ADDENDUM NO. 3

Date:	**February 18, 2021**
Project Name:	**Dean's Trail Phase 2**
Owner:	**City of Springdale**
Owner Project No.:	**ARDOT Job No. 040786, City Job No. ST1801**
Garver Project No.	**18047110**

2. In order to increase visual sight distance and for construtability the retaining wall has been revised on the south tunnel entrance. Sheets C-208, C-402, and S-601 in the Plans shall be removed and replaced with the attached sheets labeled Revision 1.

DRAWING NUMBER
C-208

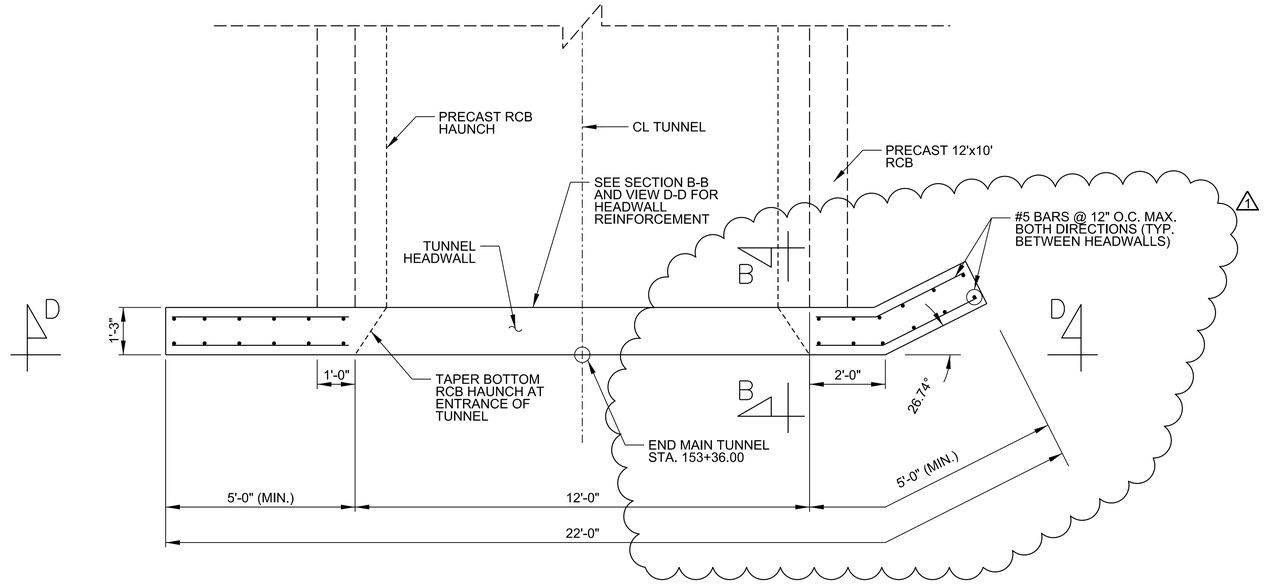
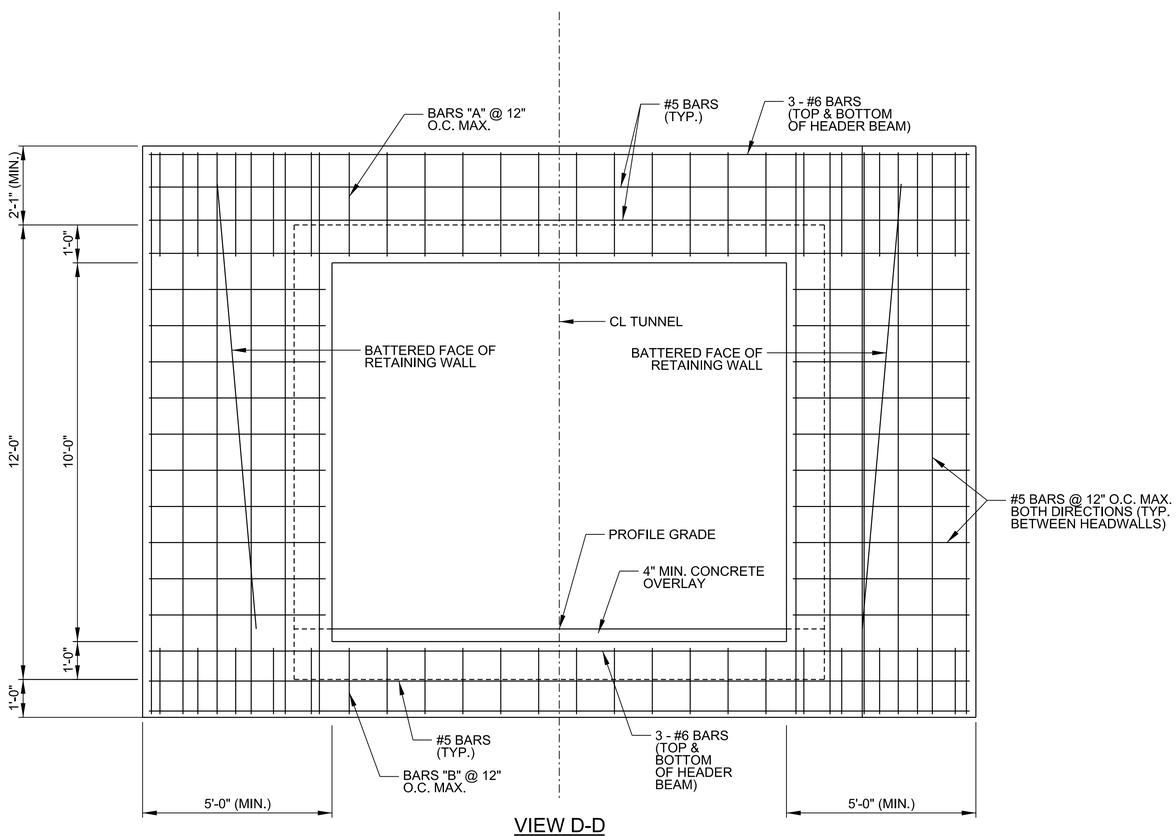
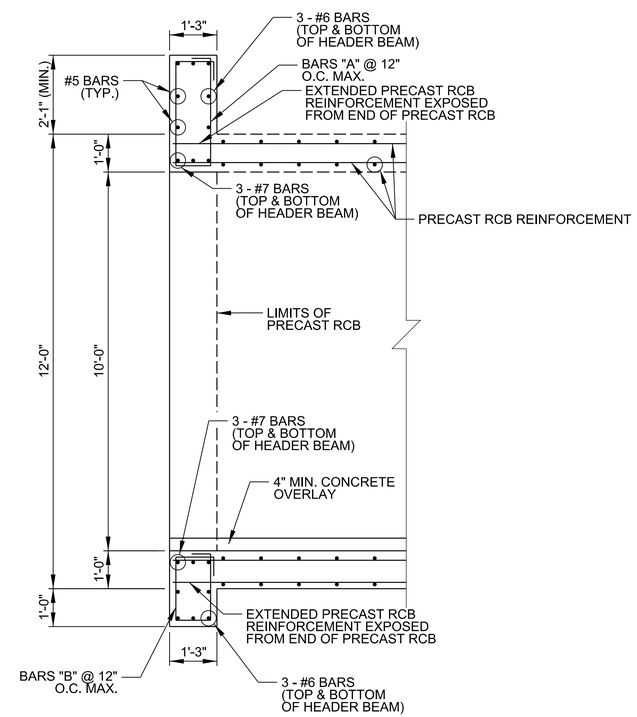
REV.	DATE	DESCRIPTION	BY
1	2/16/21	REVISIONS TO HEADWALL AND RETAINING WALL	DJW

DRAWING NUMBER
C-402

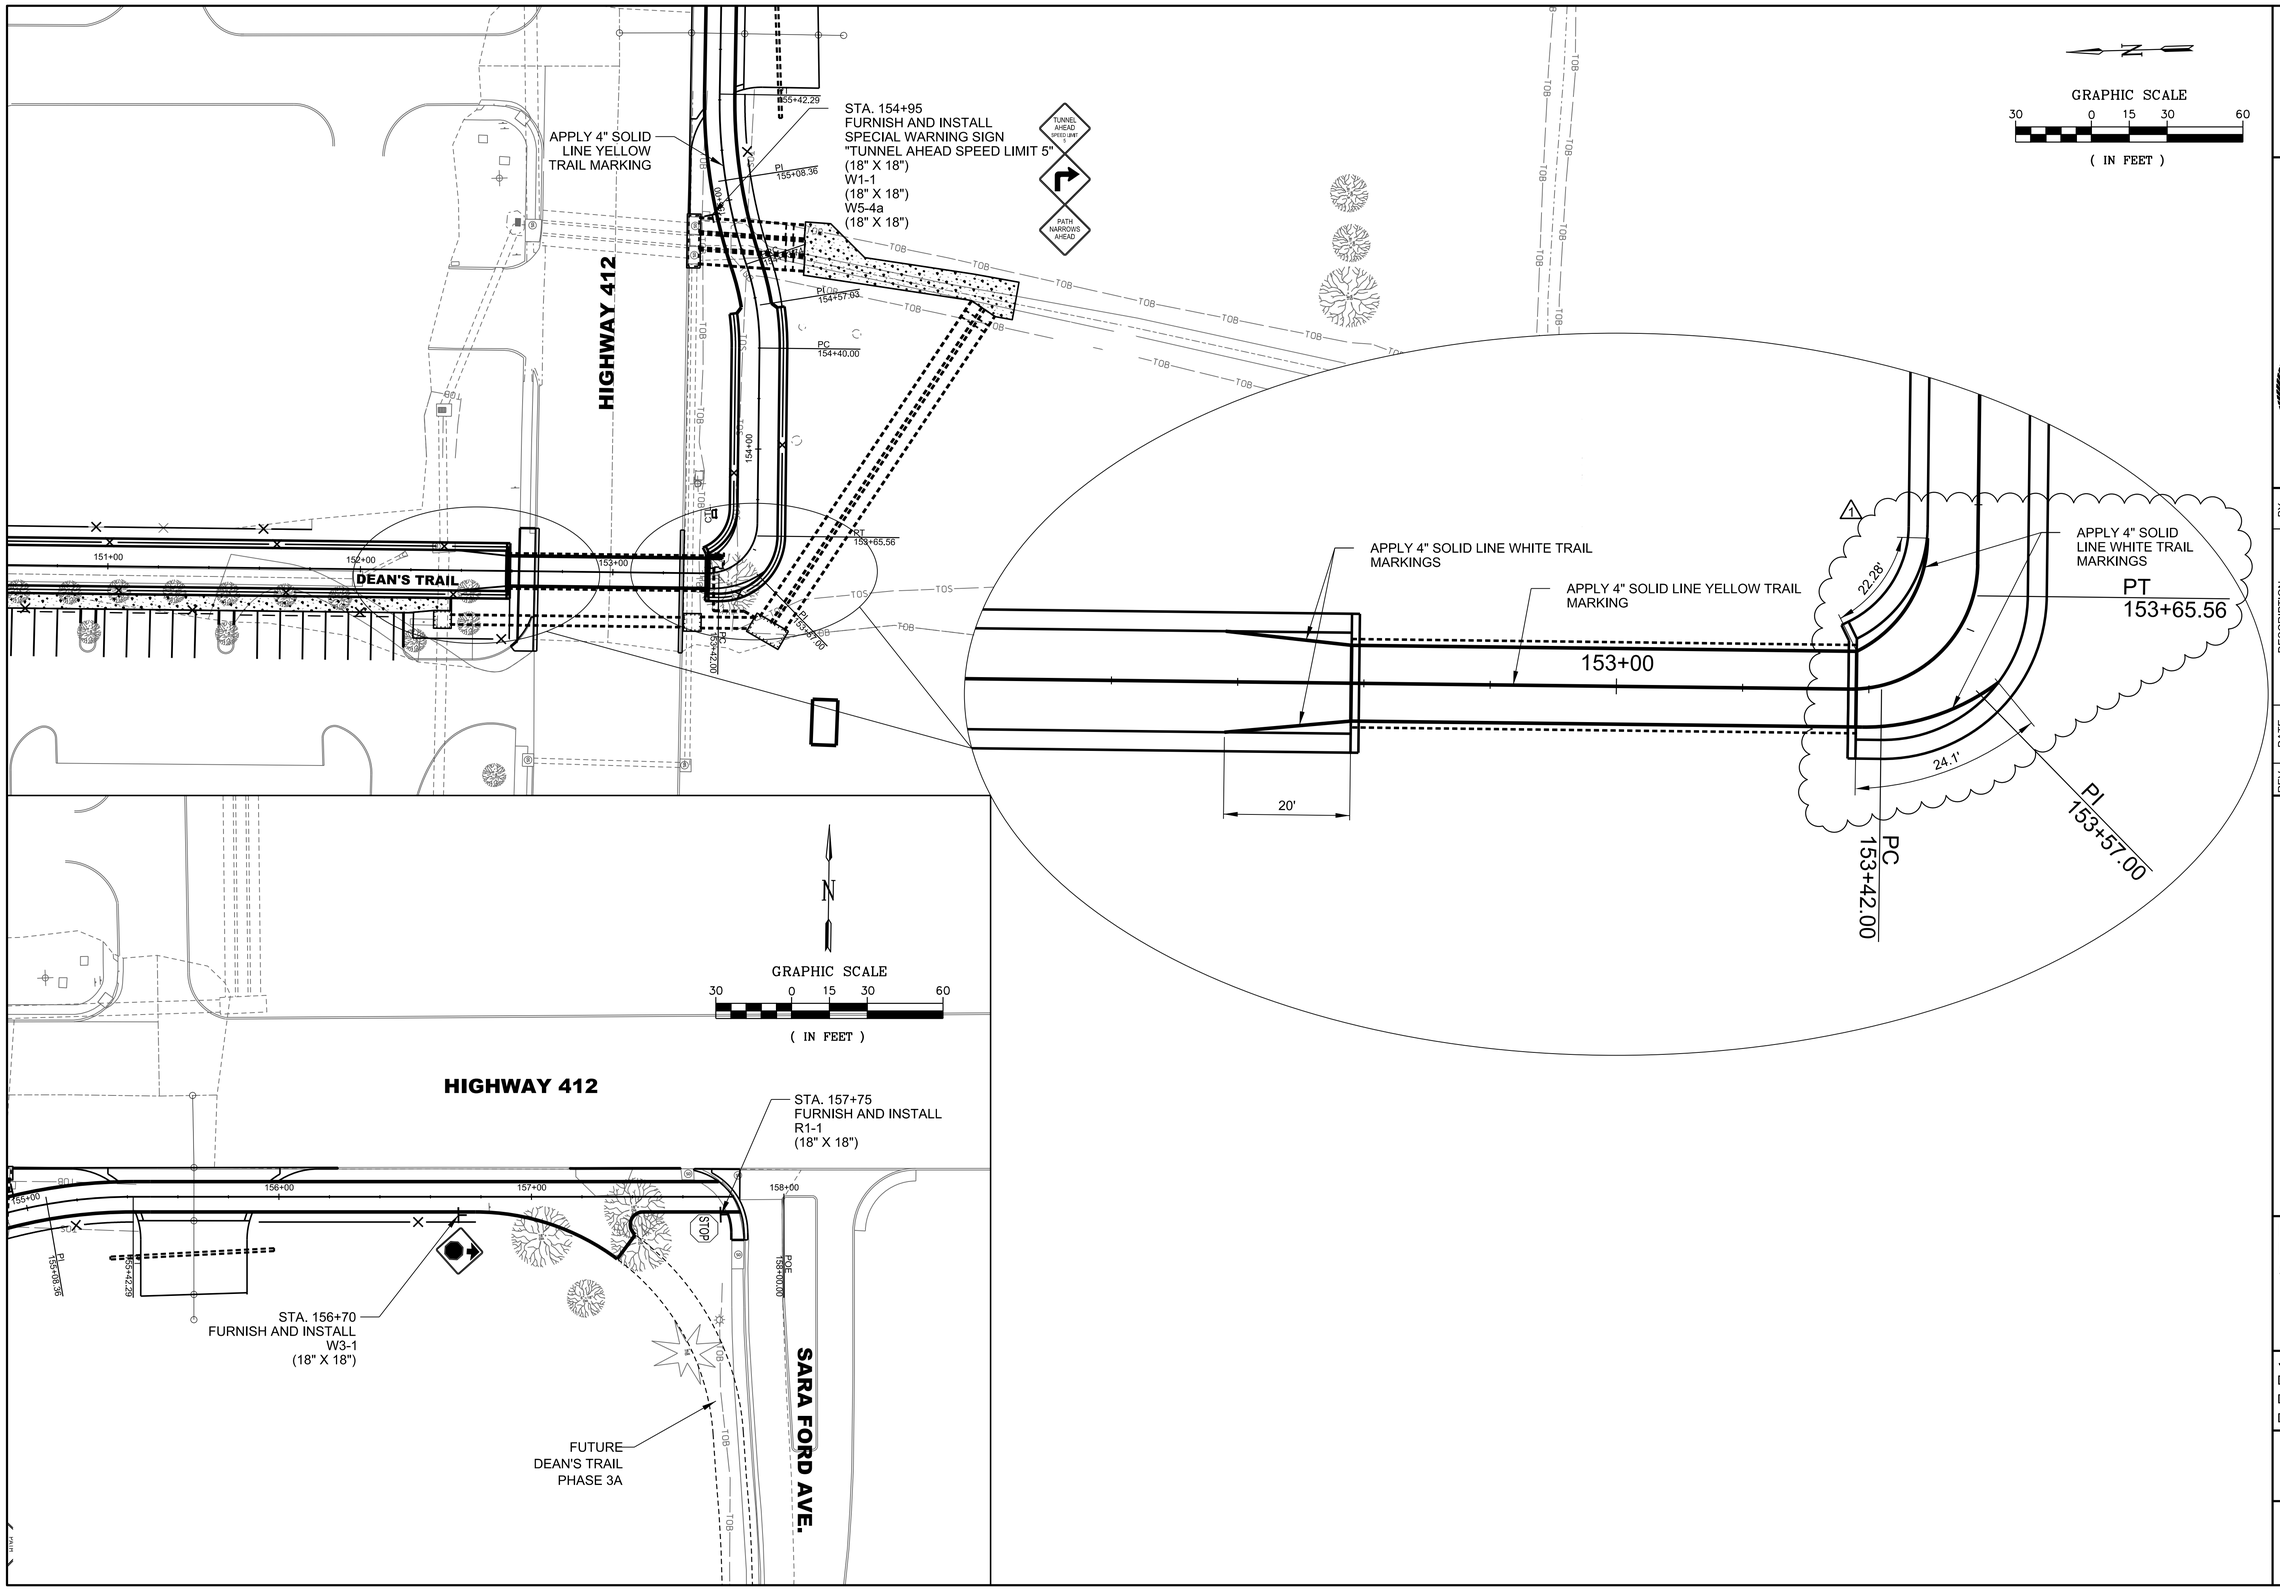
REV.	DATE	DESCRIPTION	BY
1	2/16/21	REVISIONS TO HEADWALL AND RETAINING WALL	DJW

DRAWING NUMBER
S-601

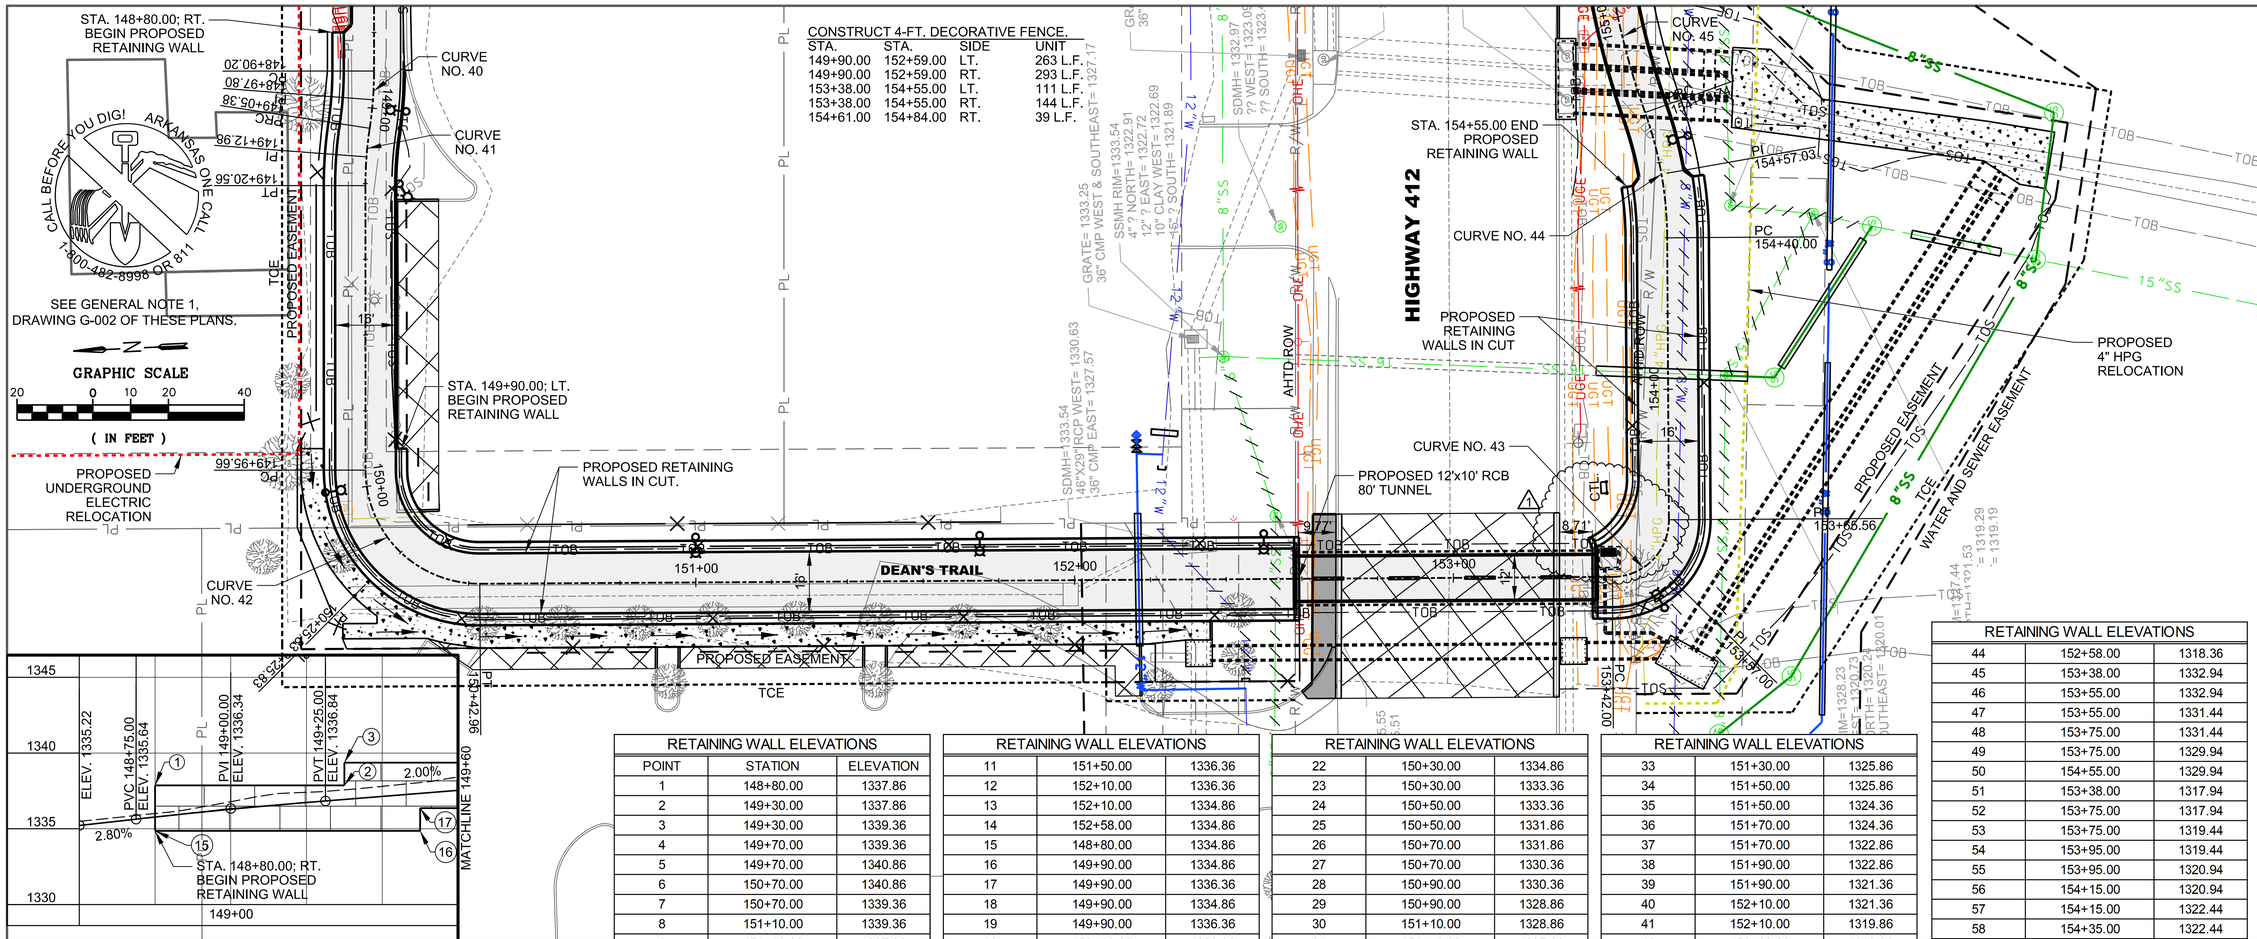
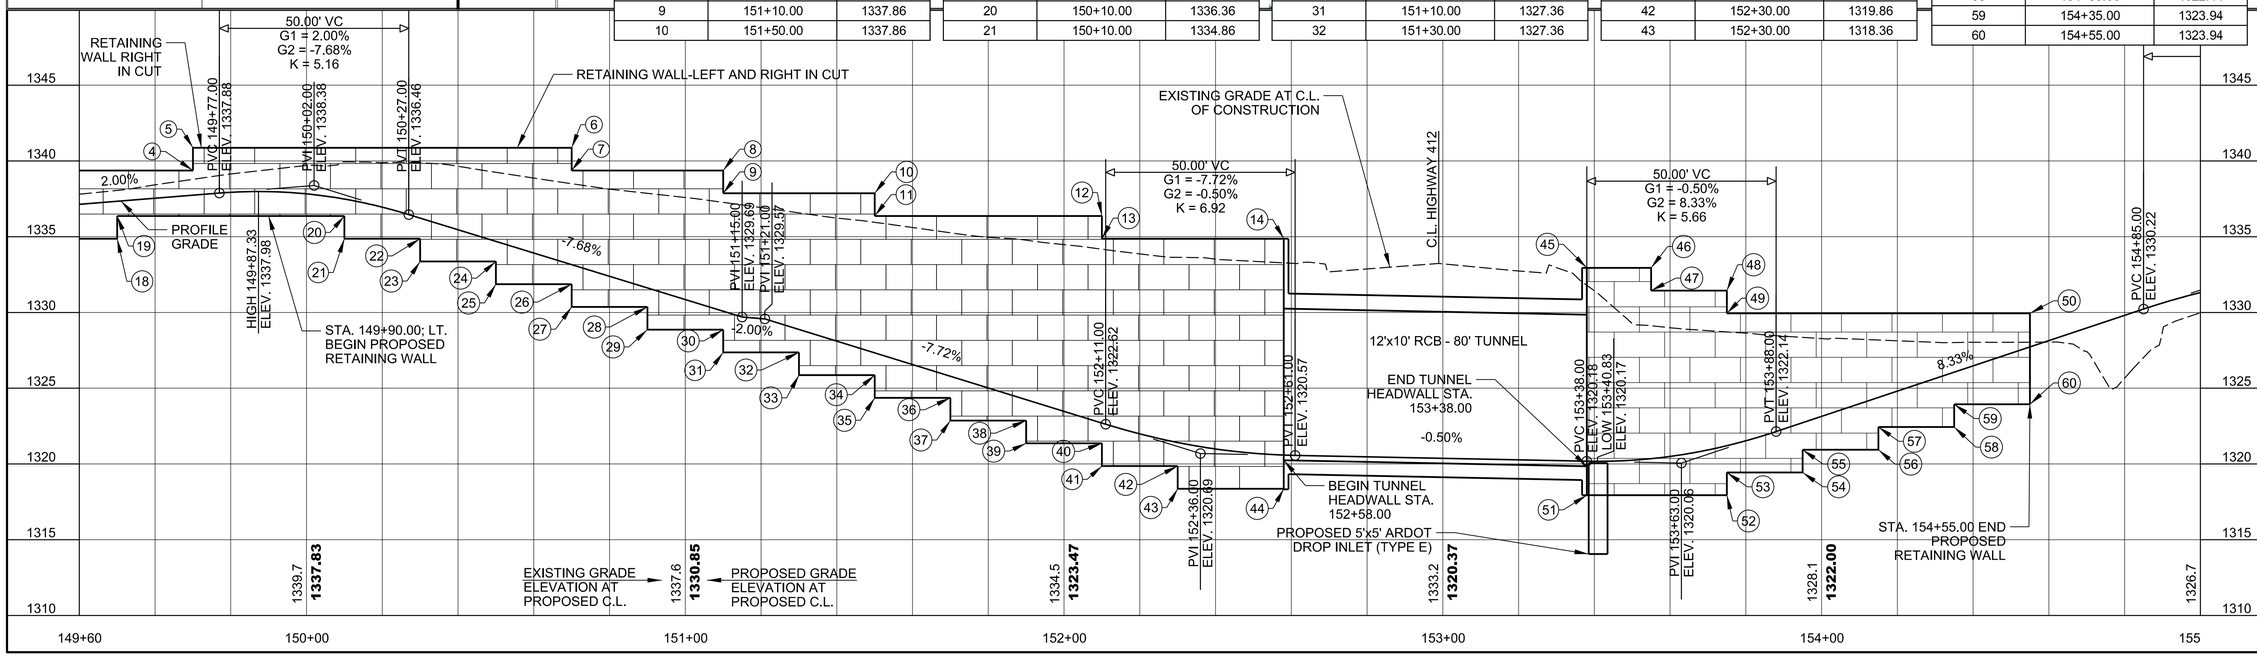
REV.	DATE	DESCRIPTION	BY
1	2/16/21	REVISIONS TO HEADWALL AND RETAINING WALL	DJW
